TITLE: PocketBeagle PocketPilot

Document Number:
POCKETBEAGLE POCKETPILOT

REV:
A2

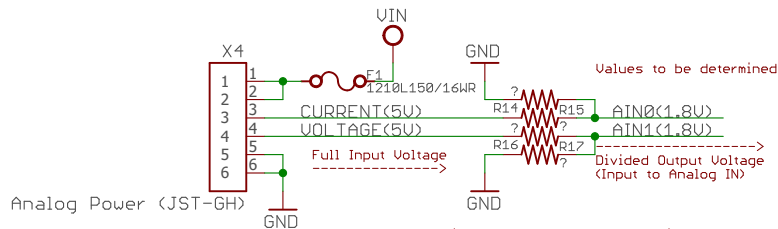
I am uncertain what to do for this connector. Are we going to follow this standard?
This information comes from <https://wiki.dronecode.org/workgroup/connectors/start>

The CURRENT signal should carry an analog voltage from 0-3.3V for 0-60A as default. For high-power units the range should be 0-3.3V for 0-120A. The VOLTAGE signal should carry an analog voltage from 0-3.3V for 0-50A as default.

The UCC lines have to offer at least 2.5A continuous and should default to 5.3V. A lower voltage of 5V is still acceptable, but discouraged.

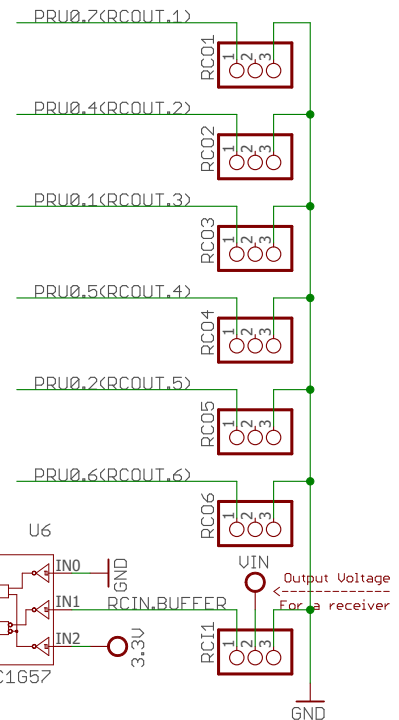
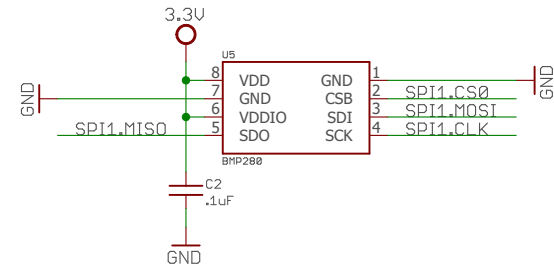
Datasheet indicates typical voltage at 1.8V but can have a max of 3.6V. VDD and VDDIO are two separate power supplies, VDD is for the Analog pressure sensor and digital function blocks and VDDIO is exclusively for the SPI/I2C Interface which I assume means you can power each at different voltages. If separate supplies are used, we must have a 0.1uF cap on each supply.
